REMARKS

AMENDMENT TO THE DRAWINGS

Fig. 4

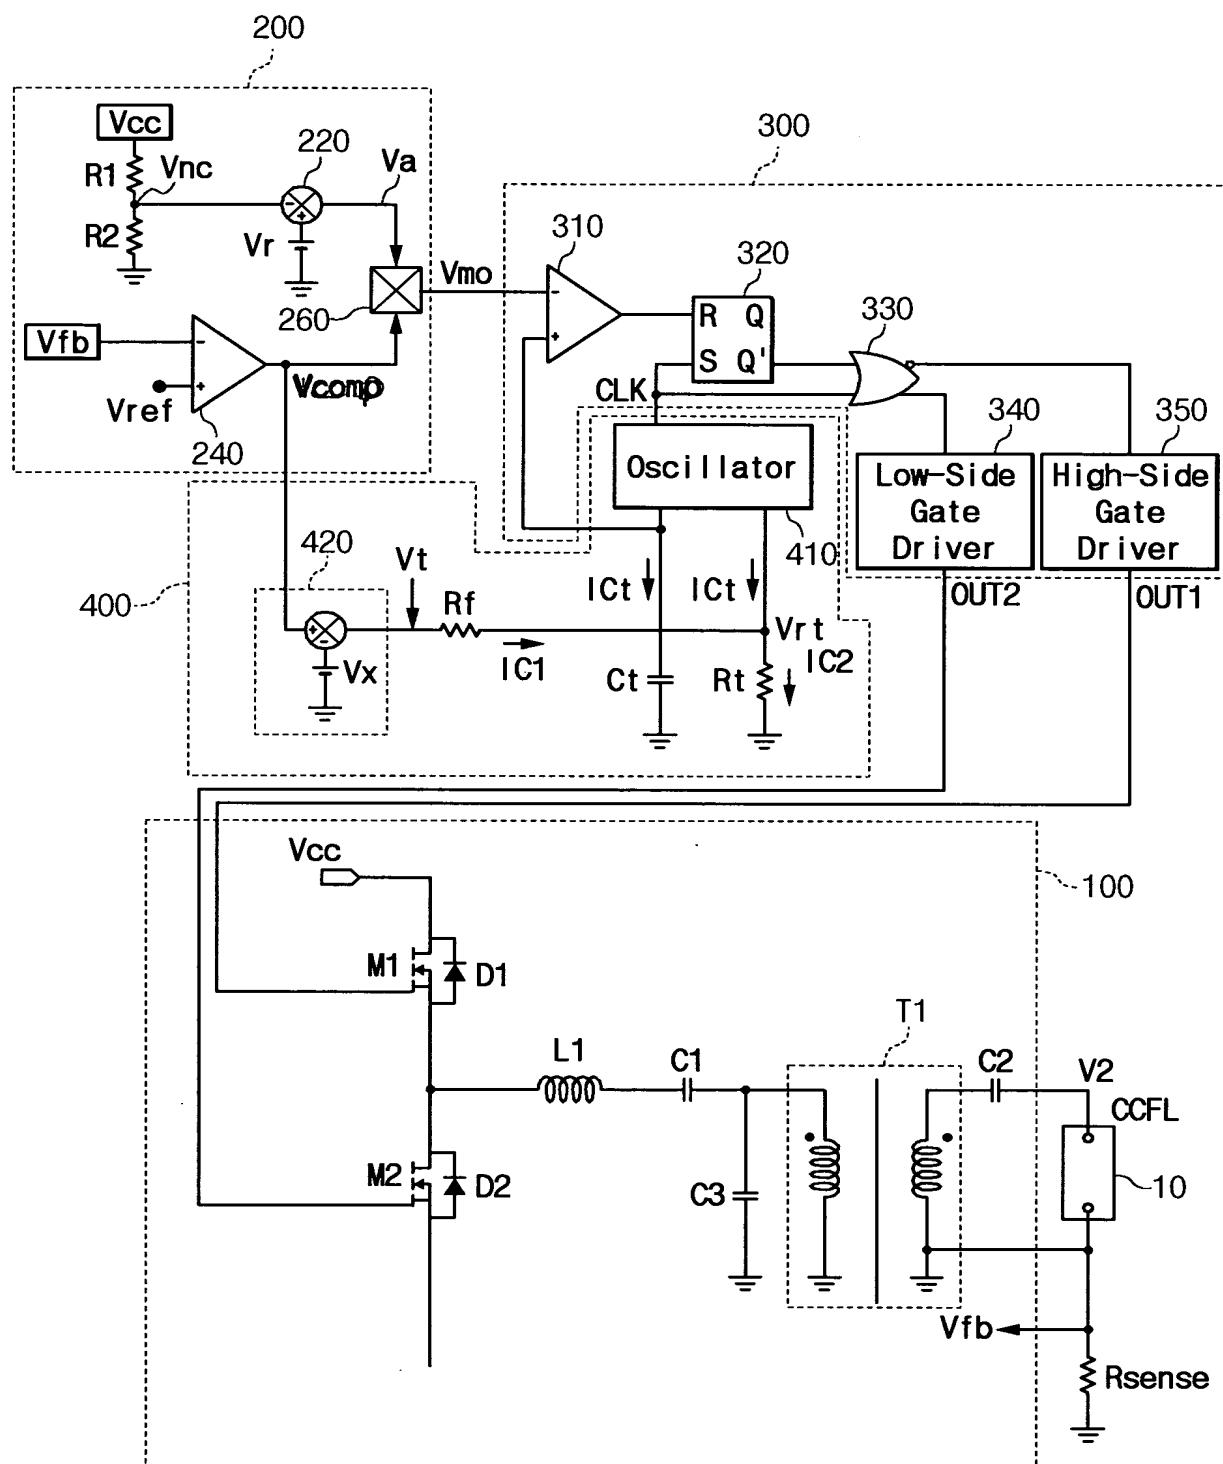
According to the Examiner, “no capacitor is seen in instant Fig. 3, although it is referred to in the specification at page 4 [para 0028]. Also, Fig. 4 is incorrect in that the input to amplifier 430 should be ‘Vcomp’ (not Vmo), see the specification at page 10 [para 0069]. Moreover, ‘Vcomp’ needs to be labelled in instant Fig. 1. Finally, it is not clear where in Fig. 1 the ‘amplifying means’ is referred to at page 5 [para 0031, line 6].”

Applicants have amended Figs. 1 and 4 of the drawings. In Fig. 1, a capacitor C3 which was not previously shown in the figure has been added. In addition, “Vcomp” is now labelled in Fig. 1. As for Fig. 4, the input amplifier 430 has been changed to “Vcomp.” Lastly, the “amplifying means” referred to is performed by comparator 240, which is described in paragraph 0031 of the Specification.

The drawings are objected to because Fig. 1 and 4 had missing or incorrect components. Corrections have been made and amended Fig. 1 and 4 have been submitted with this Response.
